LAND USE APPLICATION SUMMARY

Property Location: 4447 Upton Avenue South
Project Name: Patrick & Lisa O’Halloran New Residence
Prepared By: Suado Abdi, City Planner, (612) 673-2467
Applicant: Bryan Anderson, SALA Architects
Project Contact: Bryan Anderson
Request: To construct a 2-story single-family dwelling with a rear tuck under garage.
Required Applications:

| Variance | To increase the maximum floor area ratio from .50 to .788 (includes the basement level) |
| Variance | To allow development on a steep slope or within 40 feet of the top of a steep slope in the SH Shoreland Overlay District. |

1 PROPOSED RAIN GARDEN DETAIL
NTS

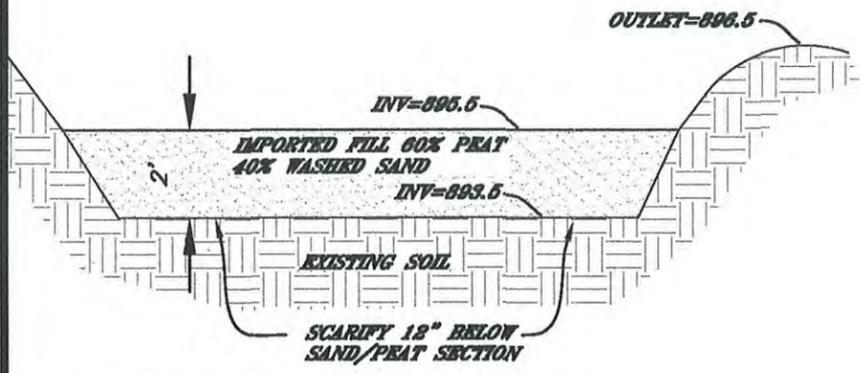
Minneapolis department of Public Works, Surface Water, and Sewers was consulted about the proposed rain garden on the rear of the lot. The rain garden would meet the required 6 feet rear setback. Below is the feedback staff received about potential issues:

1. The bottom of the rain garden appears to be about 10 feet above the first floor elevation of the adjacent home to the east located at 2716 45th Street. If not properly evaluated and designed the raingarden could potentially lead to infiltrated runoff being directed towards this house.
2. A retaining wall would be necessary at the rear property line, with the bottom of the wall being approximately at an elevation of 890. Due to the close proximity of the rain garden above the bottom of the wall could potentially impact the structural stability of the wall.
3. It is likely that during some rain events this rain garden will fill up and overflow. The overflow should be designed appropriately since the steep slopes will be susceptible to erosion from concentrated flows.

The applicant states that the completed project will reduce the grade change in the back and direct drainage from the driveway towards the new rain garden. Based on the feedback above, the rain garden would have to be reevaluated to ensure it does not negatively impact surrounding properties.

While the requested variances do not include the rain garden, staff recognizes that rain garden should be redesigned to address the feedback from Minneapolis department of Public Works, Surface Water, and Sewers (see page 2 of the report). Part of the construction management agreement is that the applicant obtains approved erosion and sediment control plan.

1. Approval of the final site, elevation, and floor plans by the Department of Community Planning and Economic Development.
2. All site improvement shall be completed by December 3, 2017, unless extended by the Zoning Administrator, or the permit may be revoked for noncompliance.
3. Approval of a soil erosion control plan as part of the site plan review application.
4. The location of proposed rain garden shall be redesigned to resolve potential runoff towards the neighbor to the east located at 2716 45th Street. Due to the rear steep slope,

the design of the rain garden shall also address solutions to possible overflow of the rain garden during rainy events.

Drw. No. 150611 TB REV 8-19 G&D Sheet 1 of 2

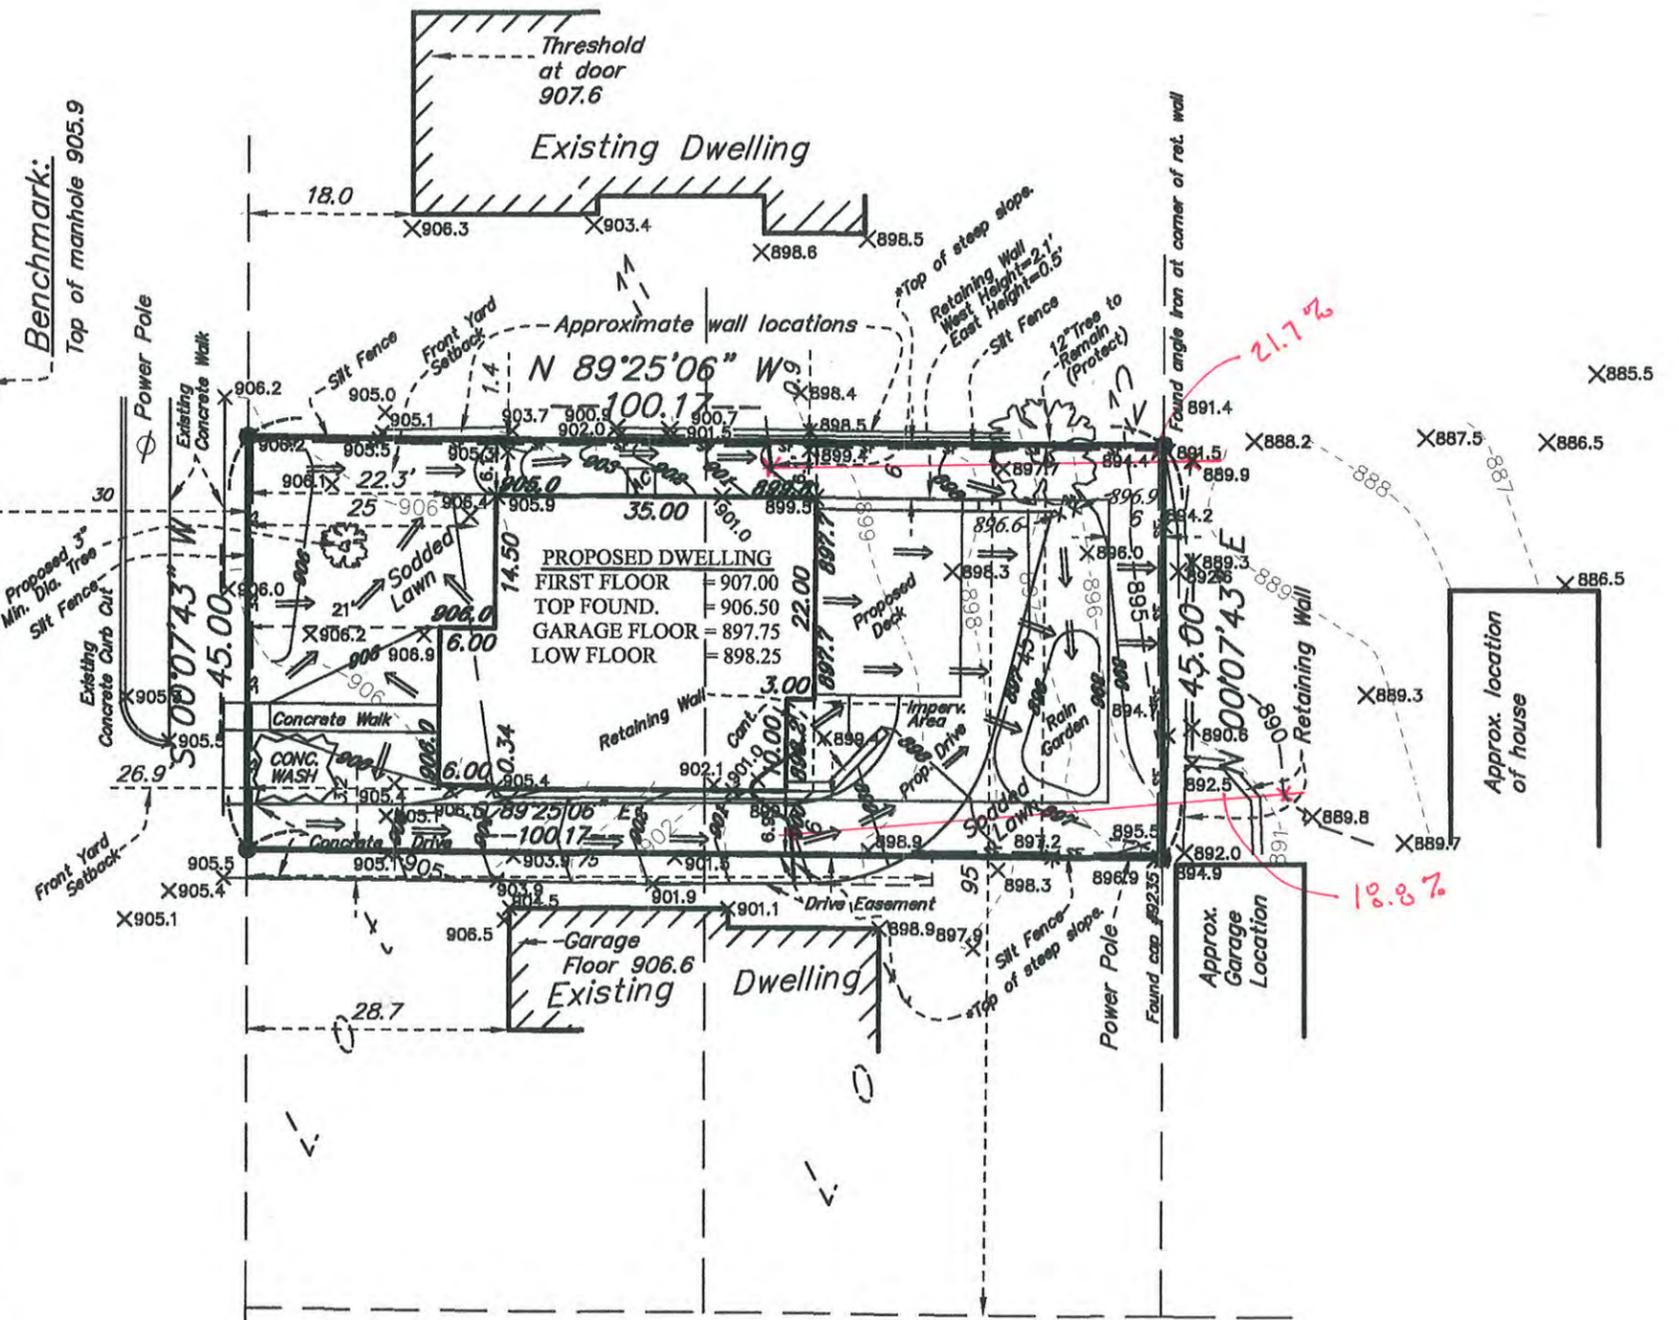
Based on the feedback received from the Minneapolis department of Public Works, Surface Water, and Sewers (page 2 of the report), the project should drain as much of the runoff from the site to the front of the house and towards Upton Avenue South. The applicant should evaluate the potential impacts the location of proposed rain garden would have to the neighbor to the east located at 2716 45th Street. Due to the rear steep slope, the design of the rain garden should also address solutions to possible overflow of the rain garden during rainy events reduce the likelihood of erosion. Additionally, a structurally designed retaining would be necessary at the rear of the property line of the subject site. A retaining wall that maintains natural grade can be built closer to the property line. However, a variance would be required if the retaining wall does not retain natural grade.

During construction, erosion control measures will include a slit fence around the perimeter of the house as shown on the site plan. Post construction, the applicant proposes to install a rain garden

on the rear of the lot. The rain garden would be setback 6 feet from the rear property line. As mentioned above, there are potential issues with the location and design of the rain garden.
